Application No. 10/715,746
Applicants: Baker, Bays & El-Kik
Reply to Action dated 04/19/2006

Docket No. P27,120 USA

Application No. 10/715,746
Amdt. Dated July 19, 2006
Reply to Office Action of April 19, 2006
Annotated sheet showing changes

FIG. 4

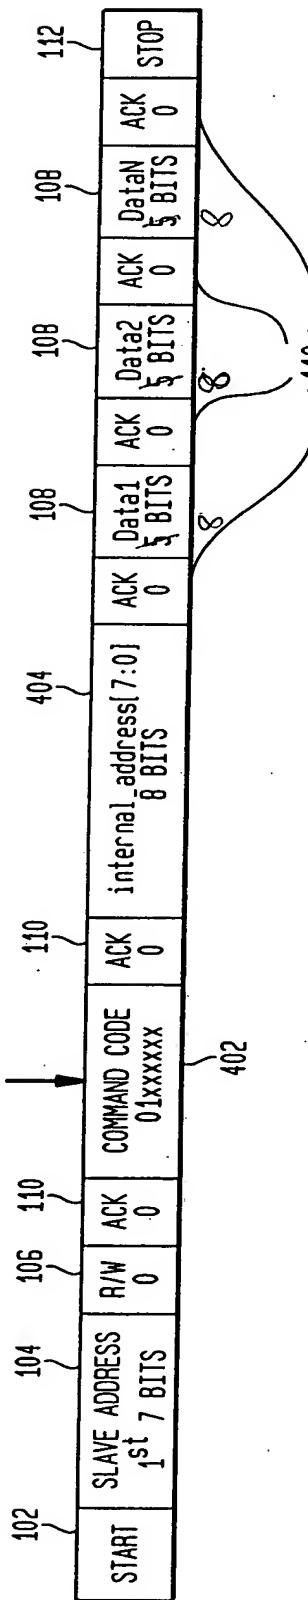
A proposed substitute Figure 4 is submitted herewith corrected as requested in section 5 of the Office Action.
